Minutes: MDS meeting September 12 th and 13 th 2017	 European forum for energy Business Information eXchange
September 21 st , 2017	MDS (ebIX [®] working group for Master Data Structuring and harmonisation in the European energy market)

Minutes – MDS project meeting

Appendix B MDS proposals for update of ebIX® Business Information Model 2016.A

- b) Add the attribute “ID Scheme Type Code” to the ebIX® model.

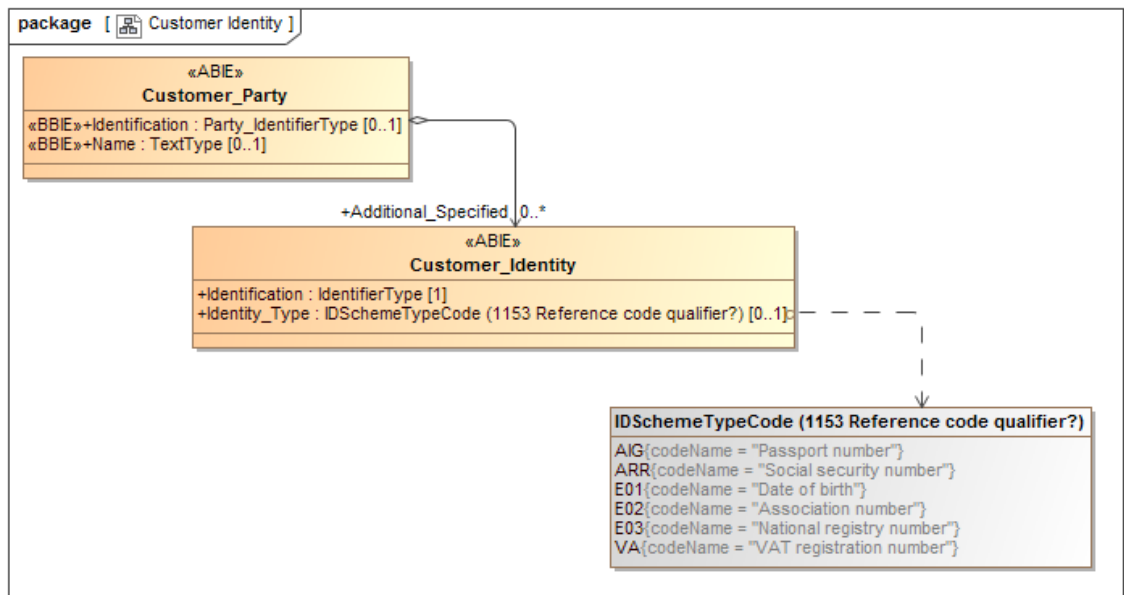
As shown in the BRS:

- As shown in the ebIX® profile:

- Approved by MDS – ETC will create the `«ABIE»` Customer Identity and related code list

e) Add a new enumeration “Contact function code” based on “3139 Contact function code”:

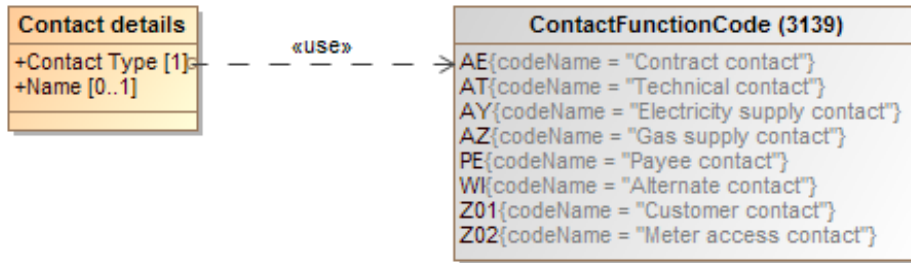
MDS requirements	3139 Contact function			
	code	name	definition	MDS comments
Main contact	AY	Electricity supply contact	Department/person to contact for matters regarding electricity supply	
	AZ	Gas supply contact	Department/person to contact for matters regarding gas supply	
	BF	Service contact	Department/person to be contacted in service matters.	possible alternatives for “Main contact”
	IC	Information contact	Department/person to contact for questions regarding transactions.	
	CU	Customer contact	The main department/person to contact at the customer	
Neighbour, House keeper (caretaker)	WI	Alternate contact	Alternate department or person to contact	MDS wants one combined code
	AV	Maintenance contact	Department/person to contact for matters regarding maintenance	
Invoice contact	PE	Payee contact	Department/employee to be contacted at the payee	
Technical	AT	Technical contact	Department/person to contact for matters regarding technical issues.

Meter reading	AQ	Quantity surveyor contact	Department/person to contact for matters regarding quantity surveying	MDS wants a new UN/CEFACT code (see below)
	MA	Meter access contact	Department/person to contact for matters regarding meter reading, including access to the Meter	UN/CEFACT will be asked for a new code
Contract contact	AE	Contract contact	Department/person to contact for matters regarding contracts	NEW

- ETC will create the enumerations and ask UN/CEFACT for new codes for Meter Access Contact and Customer Contact

- The BRS will be republished when new codes have been approved by UN/CEFACT
